meeting minutes

Project Name: University of Wisconsin-La Crosse- New Student Fieldhouse & Soccer Support Facility (DFD 15121)

Subject: User Group Meetings: (1) Recreation Sports, (2) Exercise Sports Science, (3) Athletics

Design Workshop #05 – *Rec Sports* | *ESS* | *Athletics* – November 1, 2018

1 | Fieldhouse - Women's Softball

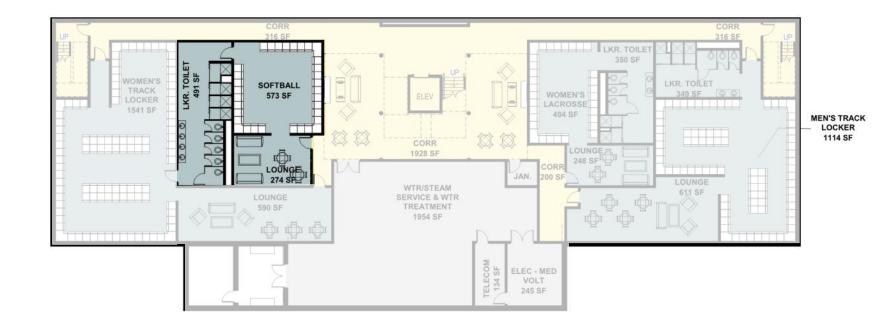
- i) Students that do not have to go to training may tend to go home w/o showering, especially softball that practices off-site.
 - c) More showers are desired at women's track and lacrosse

- d) Separate showers/toilets for women's track and softball is not necessary
 - i) RDG will look into providing more showers but not separating.
 - e) Would prefer a RAF in multipurpose rooms. This would be better than wood.

1 | Fieldhouse - Storage Review

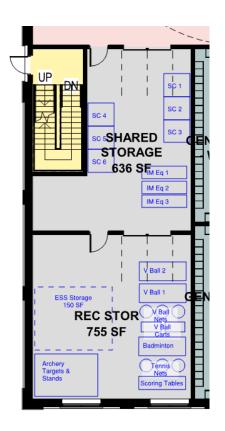
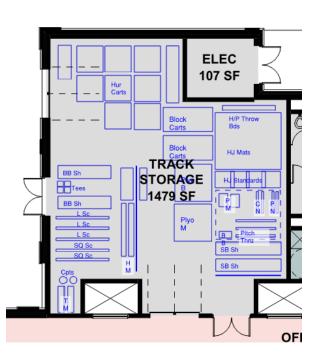
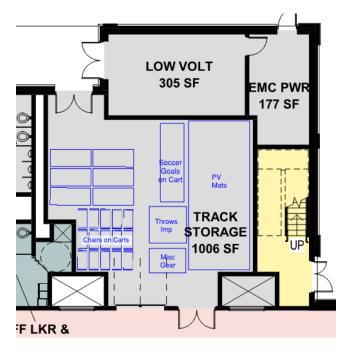
- c) One open storage space is good if there are lockable cabinets for secured storage
 - i) Provide 'cage and fencing' instead of wall and overhead door, to separate Rec Storage from Shared Storage.

- i) Operable wall would be beneficial for large track meets
 - f) Should include golf hitting mats and lacrosse goal should be added to storage. Scott S. mentioned that some chair and table storage (Small quantity) would be nice. There is currently room in the plans.

- i) Need to consider Golf and Lacrosse storage as well.
 - g) Will touch base with coaches to get reaction on infield turf
 - i) Kim mentioned that indoor throwing events aren't typically done on turf. RDG to look into this in more detail.

1 | Fieldhouse – Track Events

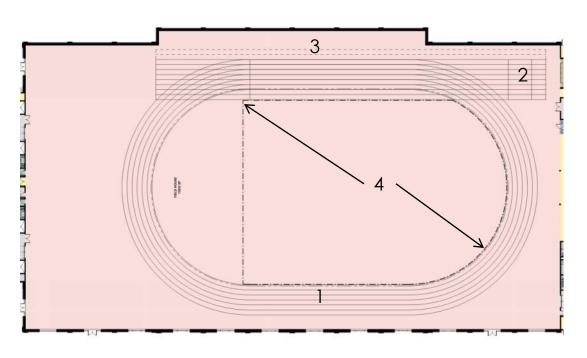
- ii) Would be nice to be able to warm-up / utilize jogging track, with spikes. What is cost difference between Mondo Super X and Mondo
- j)
- k) What is life expectancy for RAF and indoor turf? RDG to send information to UWL on replacement of indoor turf, spikable surface, and indoor spike-resistant surface.
- 10) Building exterior was reviewed by Hoang Tran, RDG.

1| Fieldhouse – Field Events

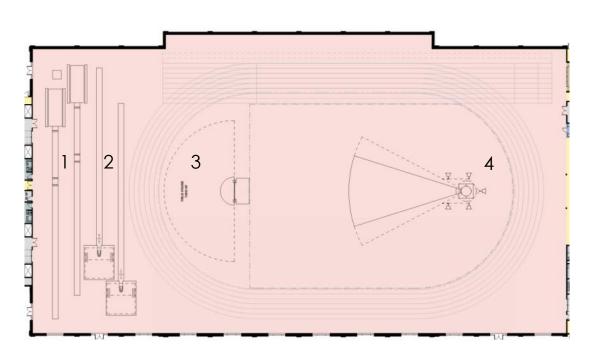
- h) Leave sand pits together
 - i) Athletics will continue to work on sketches of field event layouts
 - i) Need to review the options presented with individual coaches.
